South Texas Project
Units 3 and 4
Docket Nos. 52-012 and 52-013
Response to Request for Additional Information

Reference: Letter: Rocky D. Foster to Scott Head "Request for Additional Information Letter No. 417 Related to SRP Section 01.05 for the Nuclear Innovation North America LLC Combined License Application(ML121230021) dated May 2, 2012.

RAI 01.05-1, Revision 1**QUESTION:**

Figure 1a. STP-updated EPRI-SOG regional mainshock [independent] seismicity from the STP 3 & 4 FSAR. Magnitudes shown use the body-wave magnitude [m_b] scale.

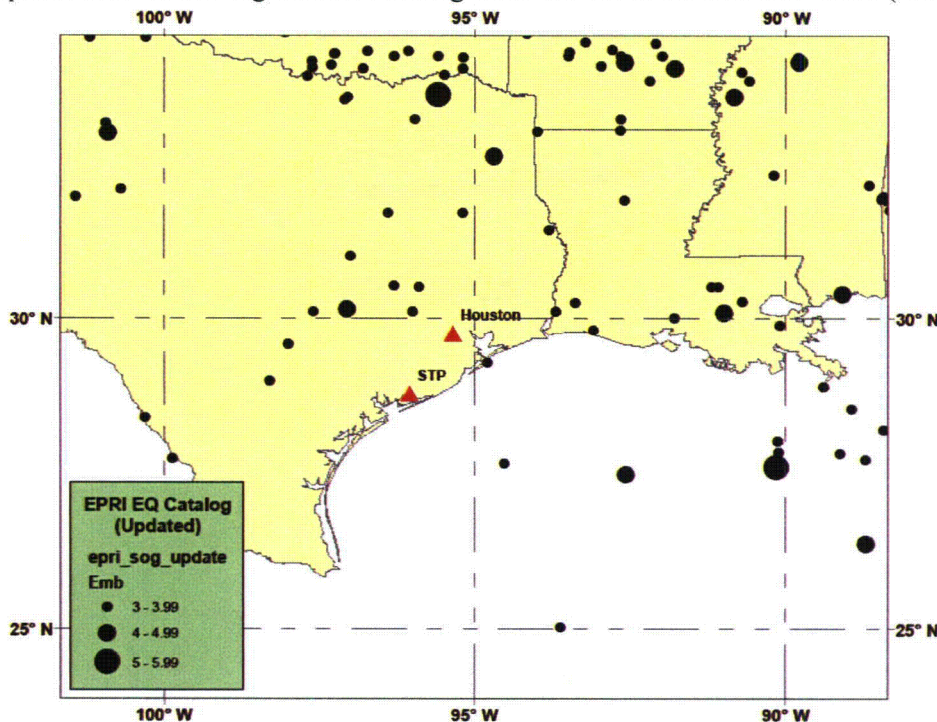
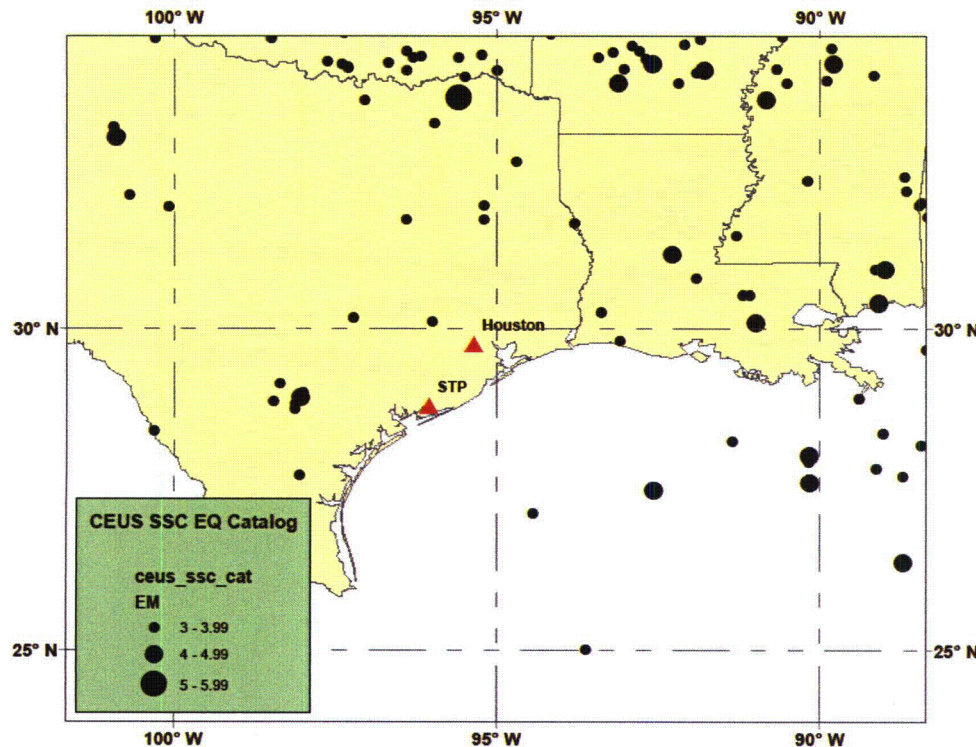
This request for additional information (RAI) specifically addresses Recommendation 2.1, of the Fukushima Near-Term Task Force recommendations contained in SECY-12-0025 as it pertains to the seismic hazard evaluation. This recommendation specifies the use of NUREG-2115, "Central and Eastern United States Seismic Source Characterization for Nuclear Facilities," (CEUS-SSC) in a site probabilistic seismic hazard analysis (PSHA). Consistent with Recommendation 2.1, as well as the need to consider the latest available information in the (PSHA) for South Texas Project Units 3 and 4 planned reactor site, the NRC staff requests that STP:

- a) Evaluate the potential impacts of the newly released CEUS-SSC model, with potential local and regional refinements as identified in the CEUS-SSC model, on the seismic hazard curves and the site-specific ground motion response spectra (GMRS)/foundation input response spectra (FIRS). For re-calculation of the PSHA, please follow either the cumulative absolute velocity (CAV) filter or minimum magnitude specifications outlined in Attachment 1 to Seismic Enclosure 1 of the March 12, 2012 letter "Request for information pursuant to Title 10 of the Code of Federal Regulations 50.54(f) regarding Recommendations 2.1.2.3, and 9.3, of the near-term task force review of insights from the Fukushima Dai-Ichi accident." (ML12053A340).
- b) Modify the site-specific GMRS and FIRS if you determine changes are necessary given the evaluation performed in part a) above.

There are several reasons to believe that earthquake hazard in the Houston-STP region varies slowly. First, the historical seismicity pattern on which recurrence parameters are based is similar for both the CEUS SSC and STP 3 & 4 COLA studies. Figures 1a and 1b show regional earthquakes as cataloged for these two studies. Differences in detail exist due to the slightly different periods of coverage and the different magnitude scales used in the two studies (body-wave magnitude, m_b , for EPRI-SOG and moment magnitude, M_w , for CEUS SSC), but the general pattern and, in particular, the general quiescence of the region surrounding both the Houston and STP sites (shown in the figures) are clear.
